V3.52 Release Notes

TRICOR®

Coriolis Mass Flow Meter

Main SW: Mv3.52 (Build E13A4238)

Figure 1 Configuration of the Fault Current

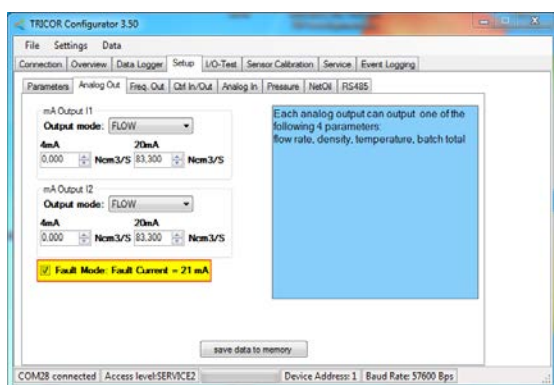
Error detection was altered in 3.50 and is now completely compliant with the NAMUR standard. The analog output can be customized to a current output upon failure. The output can be assigned to either a 3.5 mA or 21 mA output on fault detection. The default setting is 21 mA.

The configuration can done by using a Modbus coil, the display, or the TRICOR Configurator (see Figure 1).

Figure 2 Configuration of the IO deactivation

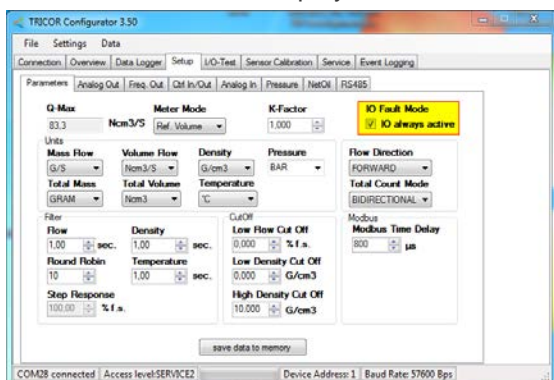
The behavior for the output deactivation on detecting critical errors is now customizable and by default not activated. If “output deactivation on error detection” is not intentionally enabled, then the outputs are never deactivated regardless of which errors are detected. Custom output deactivation configuration can be done via a new Modbus coil, the display, or the TRICOR Configurator (see Figure 2).

Figure 3 Pressure Units & changed label for Total Count mode

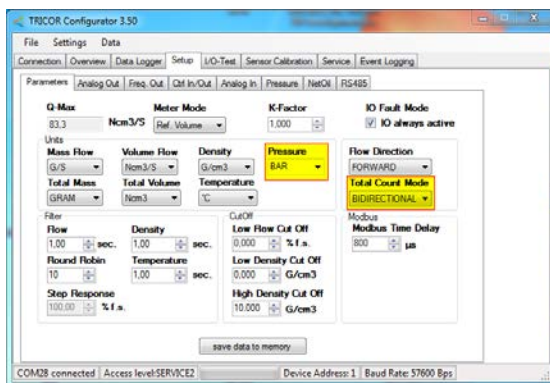
In earlier firmware versions, the pressure units and Total Count Mode could not be set from TRICOR Configurator (see Figure 3).

In version 3.50, pressure units and Total Count Mode can now be altered using TRICOR Configurator.

Figure 4: Parameters for meter mode Ref. Volume changed

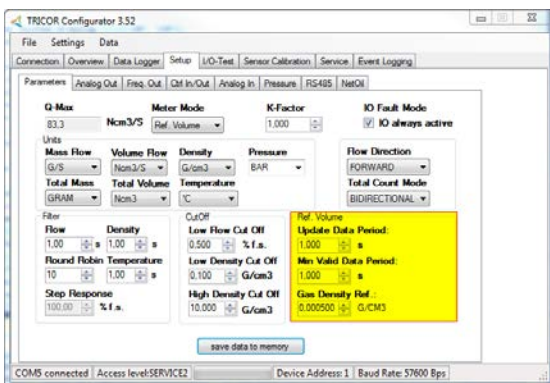
The Hotfix Tv3.52 of the TRICOR Configurator has fixed a problem from the version Tv3.50 for the meter mode „Reference Volume“ and the following parameters of this meter mode has been swapped to the “Setup → Parameters” tab (see Figure 4).

Figure 6 Overview tab for meter mode Netoil

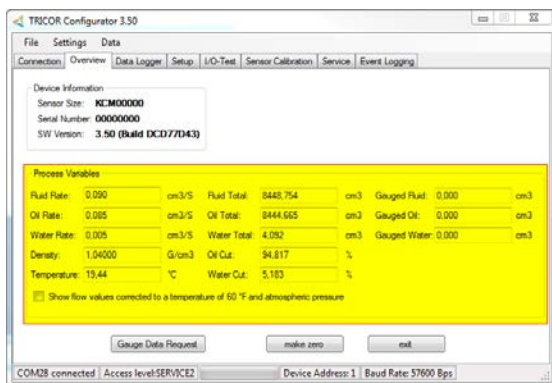
When the Netoil mode is active, the corresponding accumulators will be shown in the overview tab (see Figure 6 and Figure 5) instead of the standard accumulators.

Figure 7: Netoil Reference Densities: can be directly entered (top) or calculated (bottom)

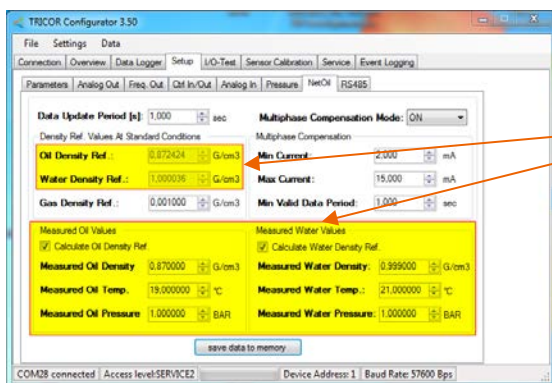
In the tab “Setup” > “Netoil”, it is now possible to enter the reference densities for water and for oil. Alternatively, those reference densities can be calculated from a measurement (see Figure 7).
